h4 Doc  
RESPONSE TO FREEDOM OF INFORMATION ACT (FOIA) / PRIVACY ACT (PA) REQUEST

2000-0096

FACILITIES: Shearon Harris Nuclear Power Plant, Unit 1

SHEARON HARRIS NUCLEAR POWER PLANT  
DOCKET NO. 50-400/LICENSE NO. NPF-63  
RESPONSE TO NRC REQUEST FOR ADDITIONAL  
INFORMATION REGARDING THE ALTERNATIVE  
PLAN FOR SPENT FUEL POOLS C & D COOLING  
AND CLEANUP SYSTEM PIPING

Figure RAI 2.5

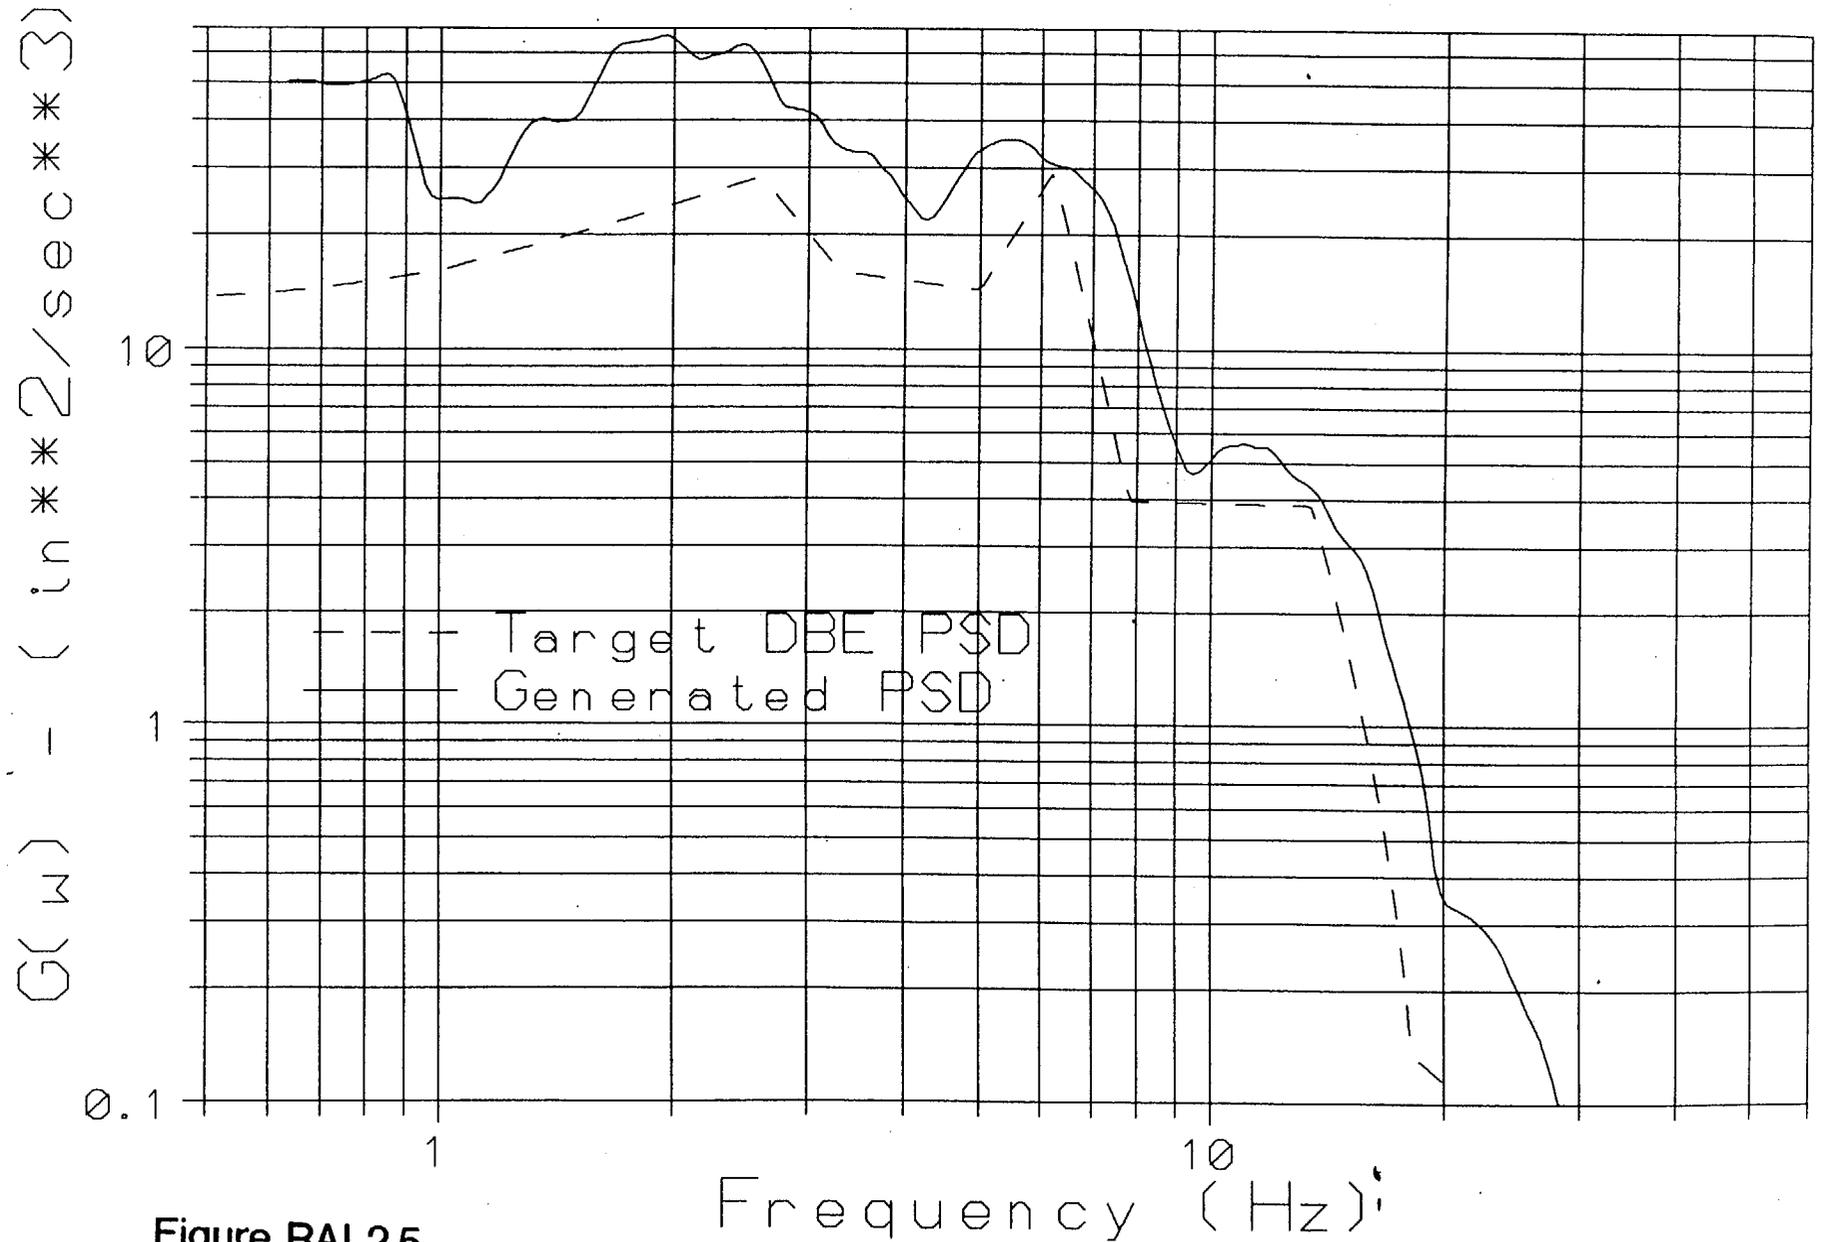
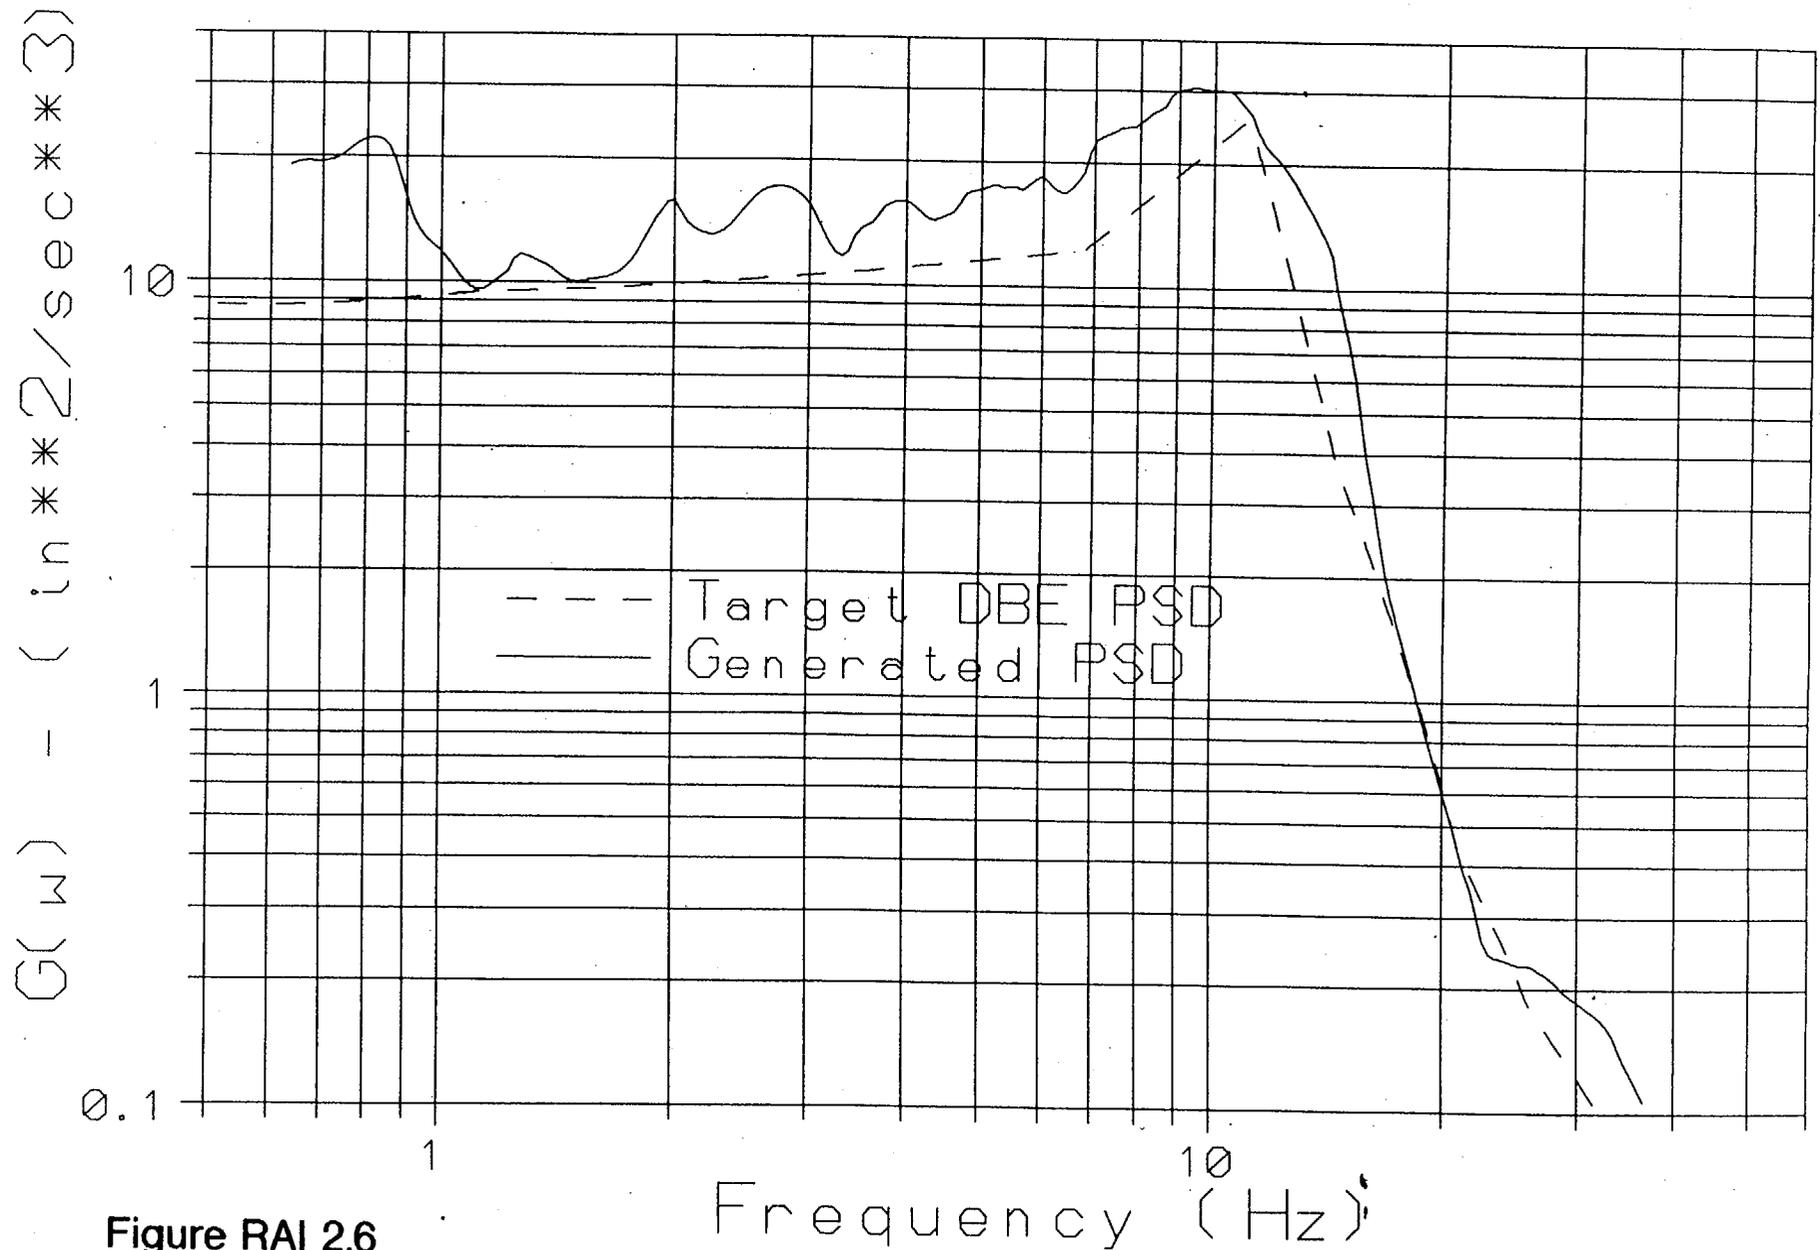
Holtec Report HI-971702 provides the details of the development of the time histories used for the Shearon Harris spent fuel pool from the design basis Response Spectra. Figures RAI 2.1 through 2.6 (Enclosure 2), reproduced from the aforementioned report, demonstrate the required enveloping of the target PSD over the frequency range important to spent fuel racks (3-7 Hz) by the PSD regenerated from the developed time histories.

Figure 5 Finite-Element Model SFP's Sectional 3-D View

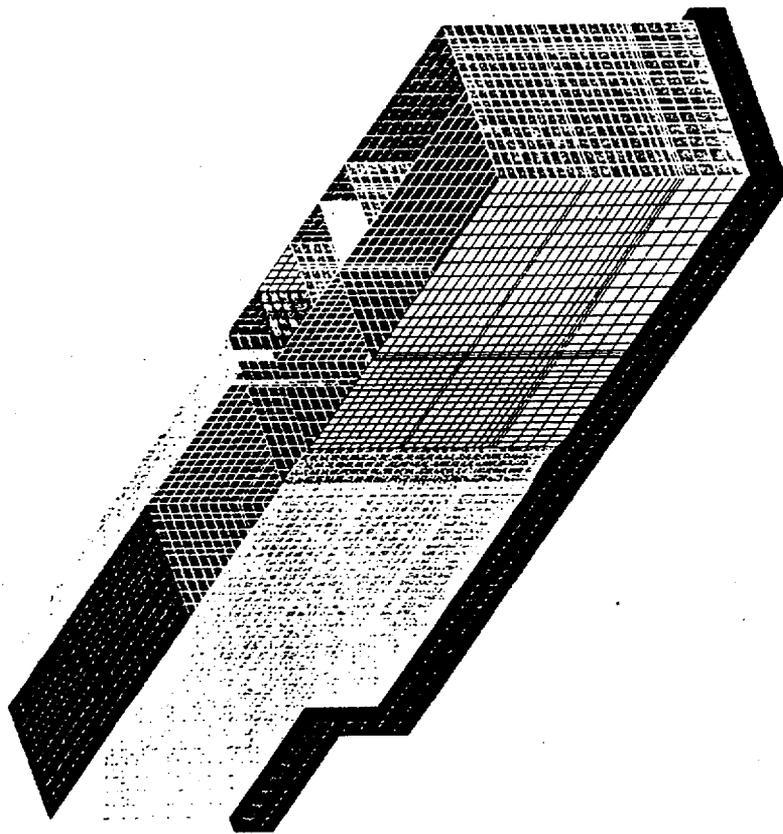
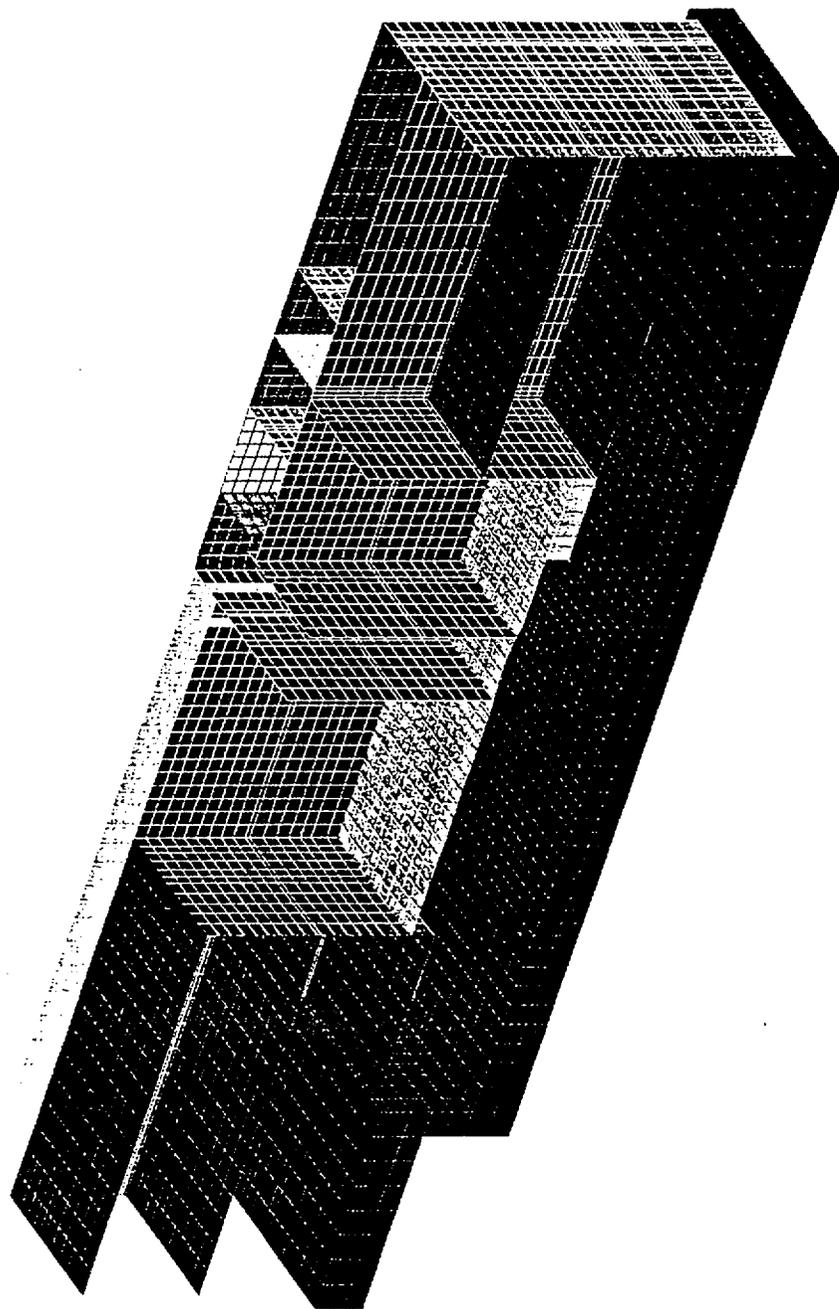
The pre-processing capabilities of the STARDYNE computer code are used to develop the 3-D finite-element model. The STARDYNE finite-element model contains 13353 nodes, 3564 solid type finite-elements, 7991 plate type finite-elements and 24 hydro-dynamic masses. Figure 4 from Holtec Report HI-981868 (see Enclosure 2) depicts an isometric view of the three-dimensional finite element model without the water and concentrated masses (racks, cask, etc.). Figure 5, also taken from Holtec Report HI-981868, shows a 3-D longitudinal section through the finite-element (see Enclosure 2).

Fig. 6 Finite-Element Model of the Mat (3-D View)

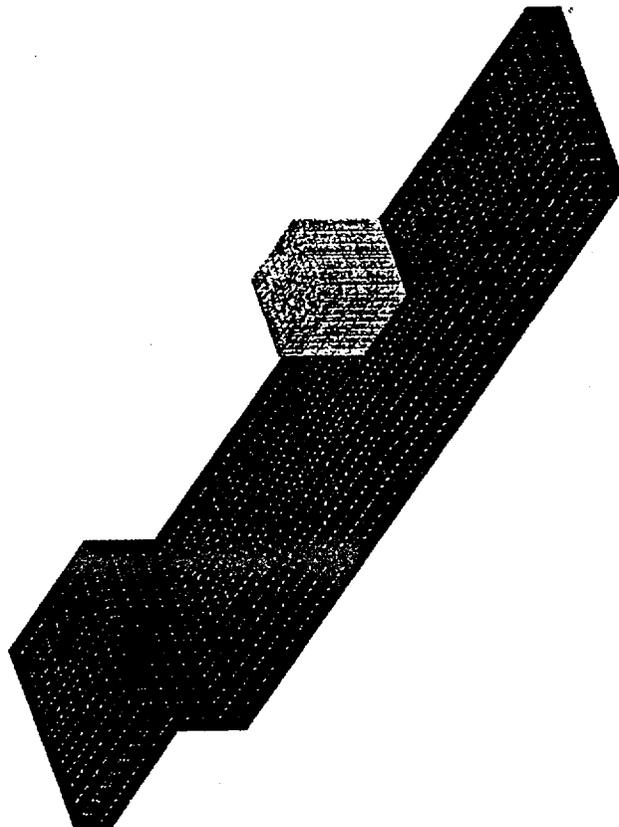
The on-grade mat, completely modeled from solid type finite-elements, is shown in Figure 6. The vertical reinforced concrete structure (walls) located parallel to the global X and Y directions of the model are depicted in enclosed Figures 7 and 8. These elements are constructed by employing plate type finite-elements which account for the shear deformation that is an important factor in the structural investigation of thick plates. Figures 6, 7, and 8 are also taken from Holtec Report HI-981868 and included in Enclosure 2.
